**RE: Traffic Impact Study & Parking Review
Dada Bhagwan Vignan Institute
SSE 20-02-1680**

Sam Schwartz Consulting, LLC (Sam Schwartz) has reviewed the above referenced application. Specifically, Sam Schwartz has reviewed the following materials with a focus on traffic and parking impacts:

Mosque (562)

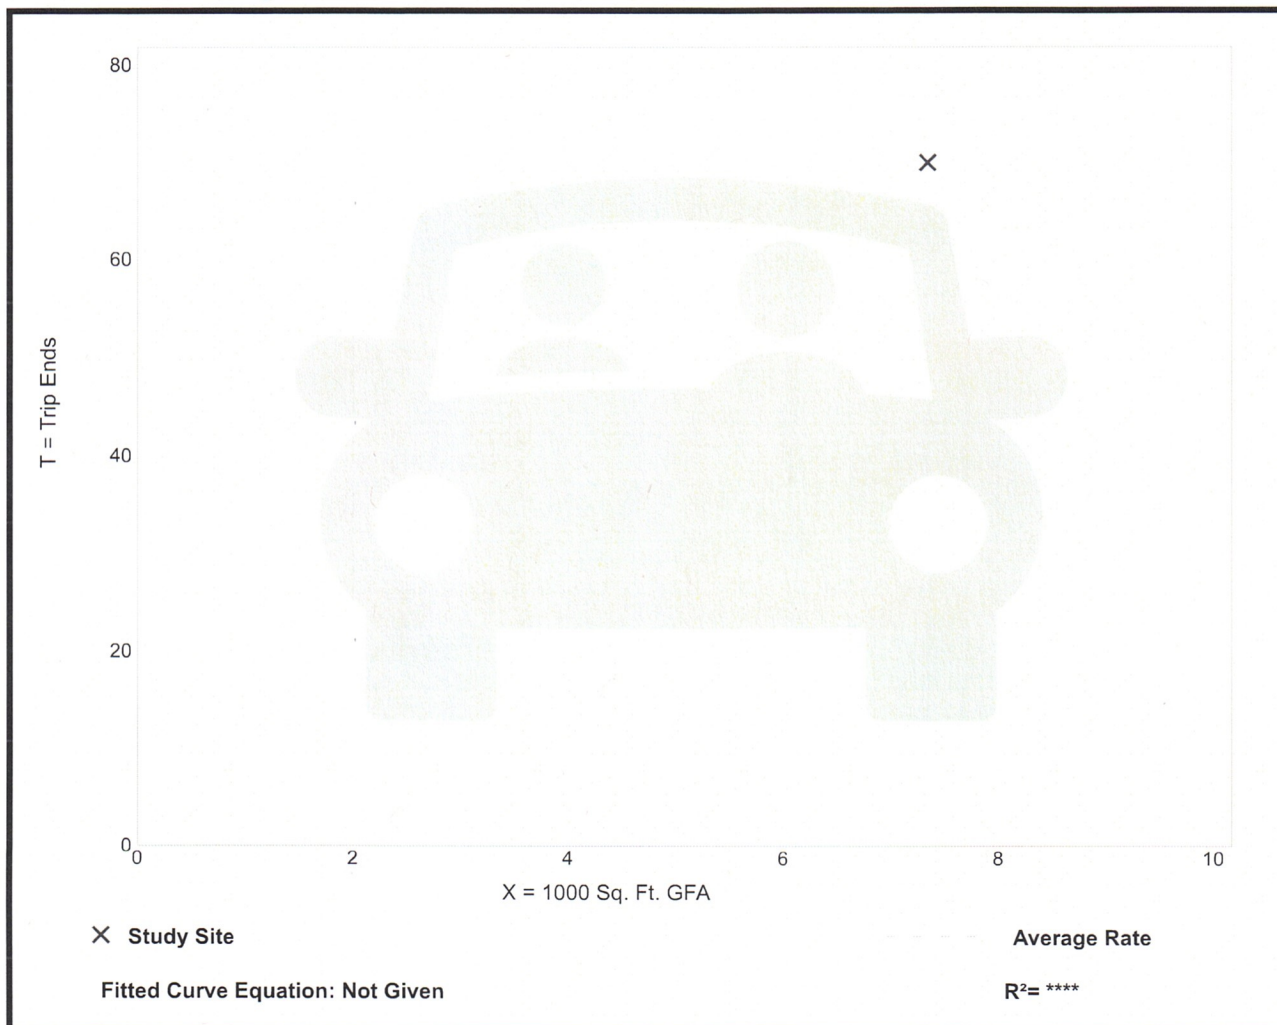
Based on the Institute of Transportation Engineers (ITE) Trip Generation Manual, 12th Edition (21,833 gfa). **ATTACHMENT B** contains detailed ITE Trip Generation calculations.

Land Use 562 Mosque

Friday AM Peak	208 (of the Generator) 3.5x higher
Friday PM Peak Hour	401 (of the Generator) 6.5x higher

The Board could request the applicant prepare revised intersection analyses based on 100 vehicles entering/exiting the site and another using 150 vehicles to fully understand the traffic impacts along South Middlebush Road (SMR).

Mosque (562)

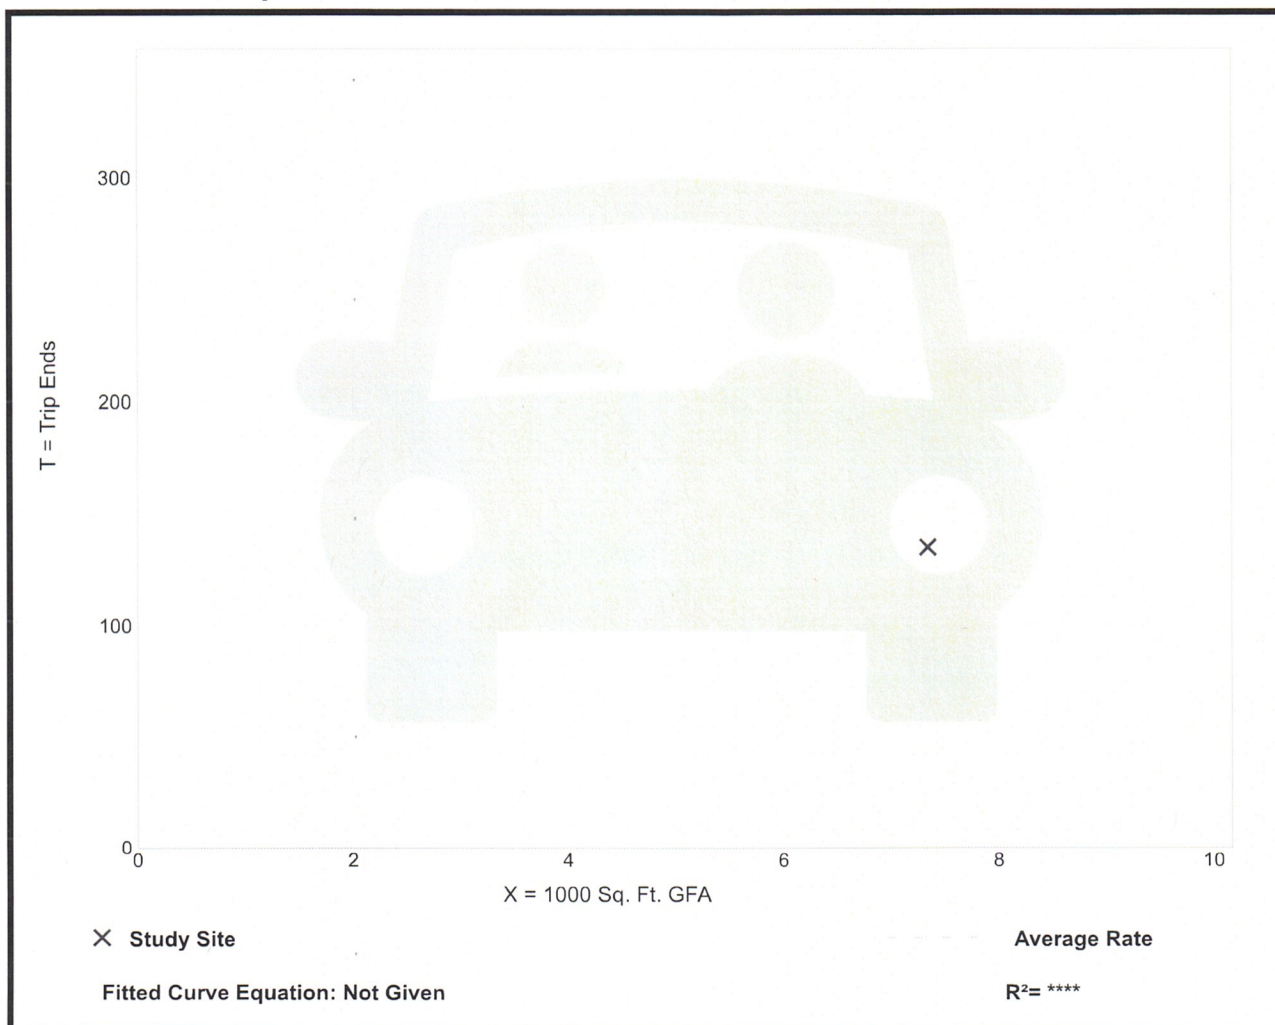
Based on ITE, there would be 3 to 6.5 times the estimated new vehicles stated in the traffic report.

Church (560)

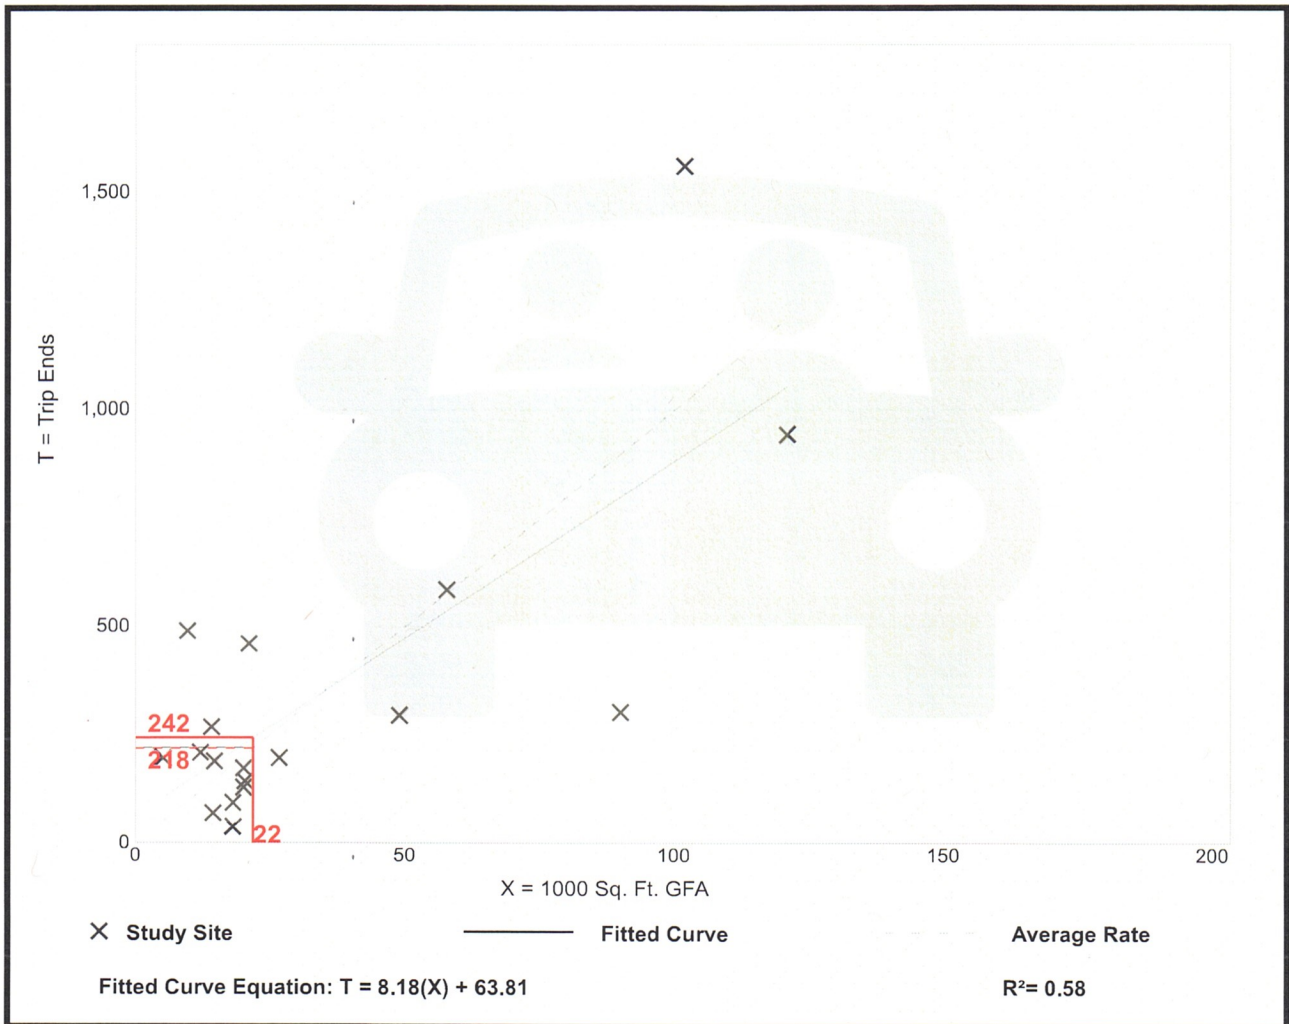
Land Use 560 Church

Sunday Peak Hour	242 (of the Generator) 4.0x higher
------------------	---

Synagogue (561)

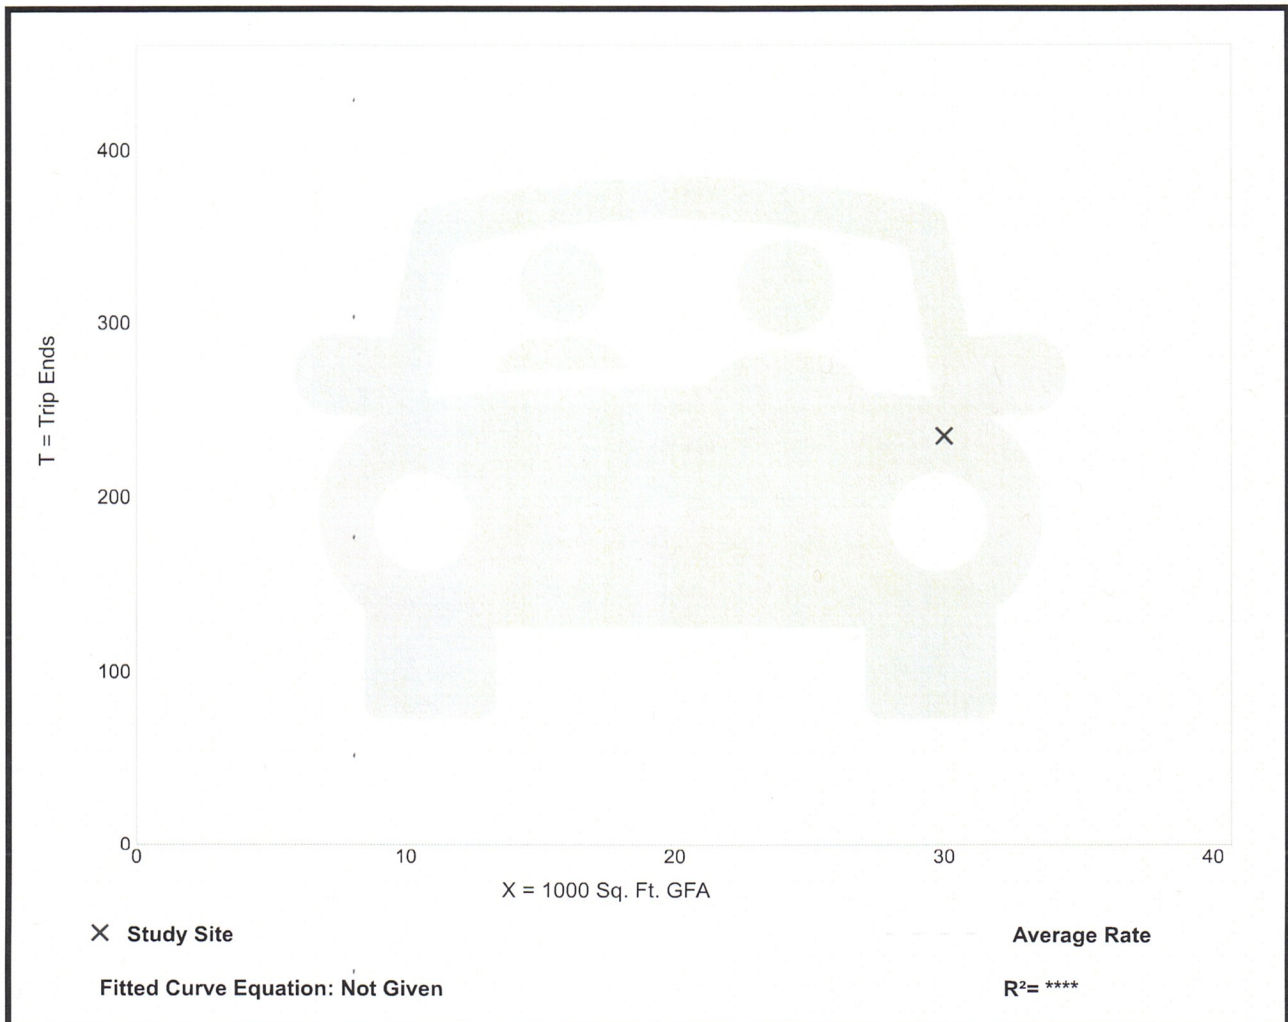
Land Use 561 Synagogue

Sunday Peak Hour	171 (of the Generator) 3.0x higher
------------------	---
